Subject: McGuire Nuclear Station, Units 1 and 2
Docket Nos. 50-369 and 50-370
Unqualified coatings inside Containment
Request for NRC approval

Unqualified Coatings Inside Containment

Figure 6-196 (Part 1 of 2).
Containment Sump

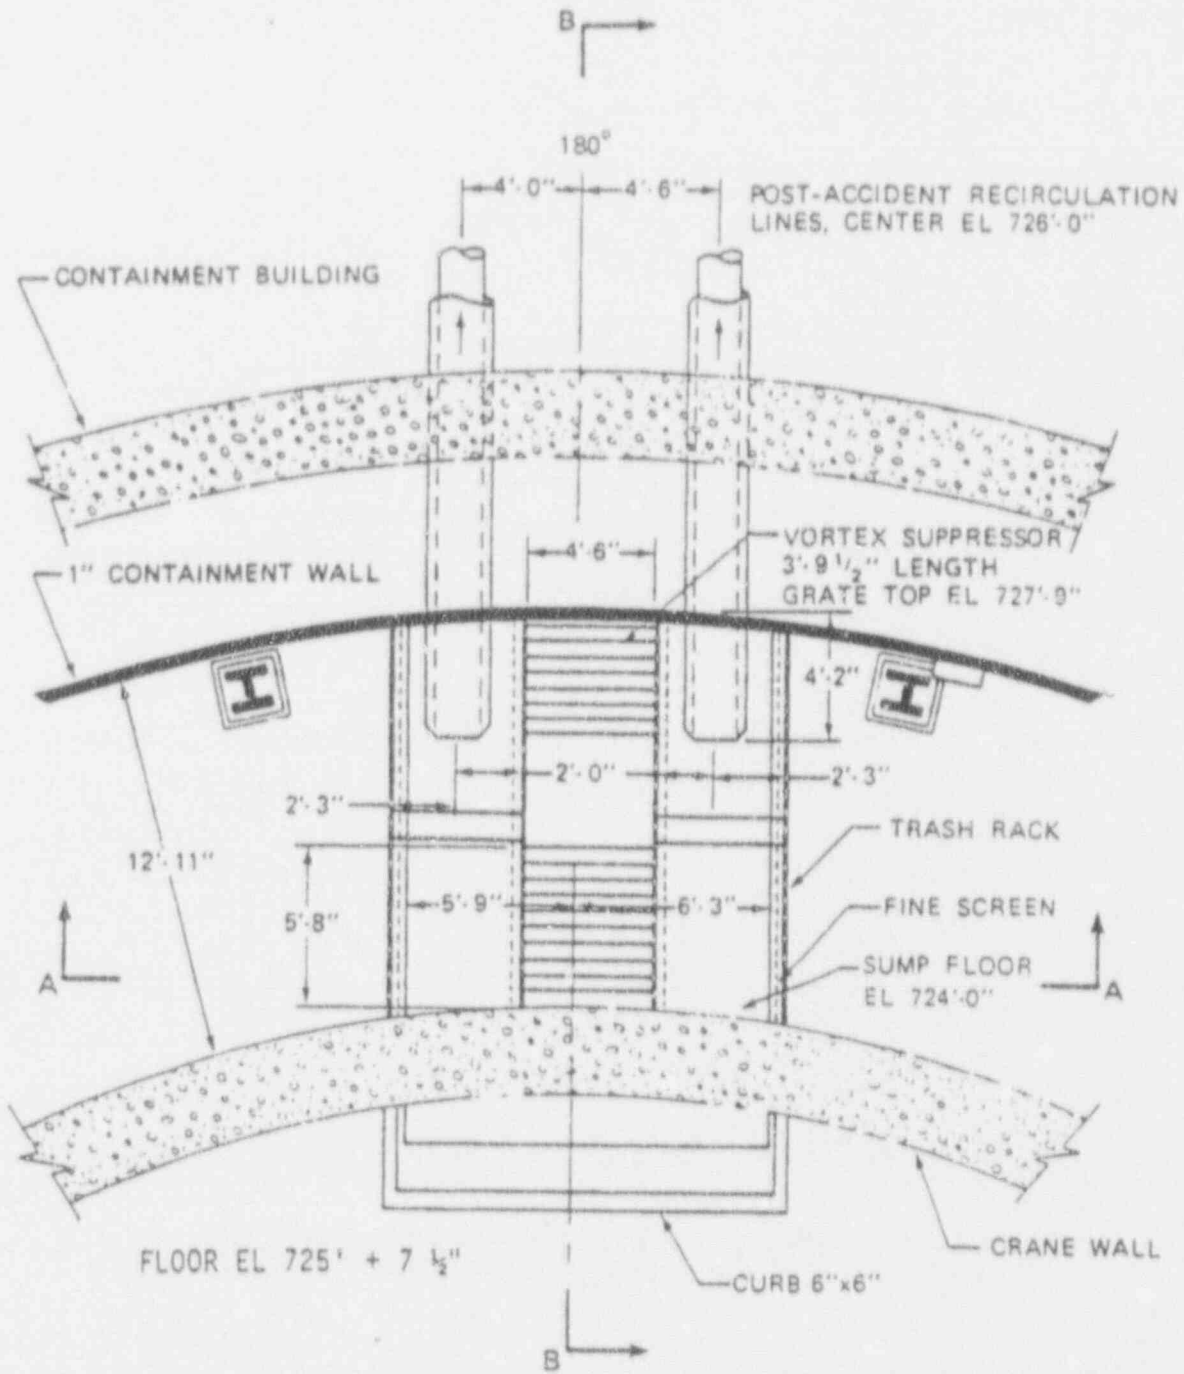
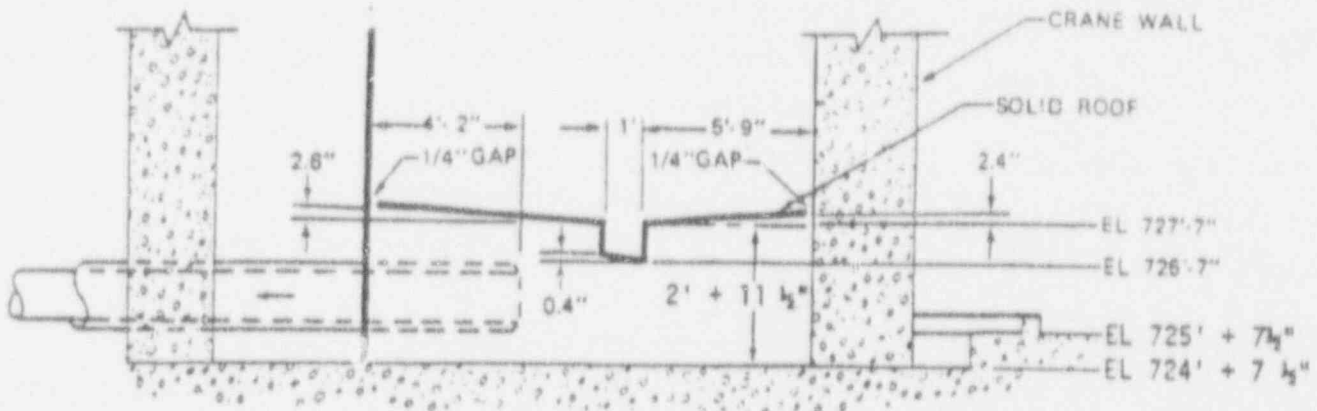
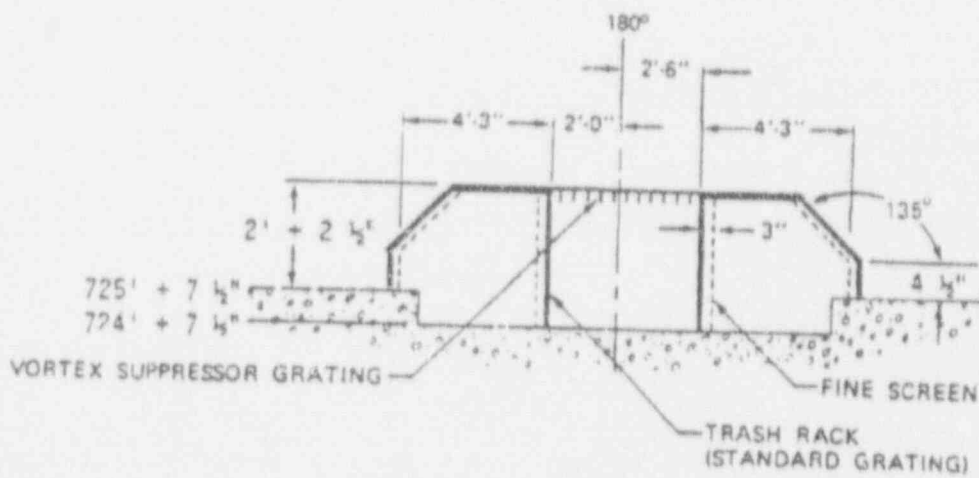
The design of McGuire does not provide for a Containment sump as such. The lower compartment of the Containment collects sufficient volume of water following the injection phase of safety injection to allow the initiation of recirculation. Water collected in the lower Containment compartments reaches the sump by flowing through a series of spare penetrations in the polar crane wall located near the Containment floor level. Refer to Figures 1-10 and 1-16 for plan and elevation drawings of the Containment sump. The design details of the Containment sump are shown on Figure 6-193.

The Containment sump structure, which is located in the pipe tunnel outside the polar crane wall, consists of an outer trash rack made of stainless steel grating to prevent large debris from reaching the inner screen. A fine mesh inner screen is provided to prevent particles larger than .206" in diameter from passing through. A removable solid top deck is provided to facilitate inspection of the structure and pump suction intake.

After a LOCA, the potential debris that could be stripped off will not adversely affect the operation of the emergency recirculation cooling system. Dense debris including failed coatings (specific gravity greater than 1) settles to the floor and cannot reach the Containment sump structure. This is accomplished by maintaining a very low inlet velocity of .24 fps, as determined by Alden Research Laboratory (ARL) from sump model testing. Debris including paint chips, insulation, etc. would be generated during the initial blowdown of the LOCA; thus, there would be an approximate minimum time of twenty minutes for particles to settle before any suction is taken from the sump. This twenty minutes also allows the water level to rise above the coverplate, thus preventing floating debris from blocking the screen. No vortex formations or air entrainment will occur at the sump as determined by ARL sump model test, therefore floating debris will not be pulled into the sump. However, if debris were able to reach the sump, the fine mesh screen (1/4" mesh size) is provided to prevent degradation of ECCS performance. The Containment spray nozzles, which have 3/8" spray orifices, are not subject to clogging by particles less than 1/4" in maximum dimension. All other valves, pumps, and heat exchangers have sufficient clearances to pass particles of less than 1/4". ARL sump model tests also showed that 50% screen blockage (67.5 square feet screen surface area) does not degrade ECCS performance.
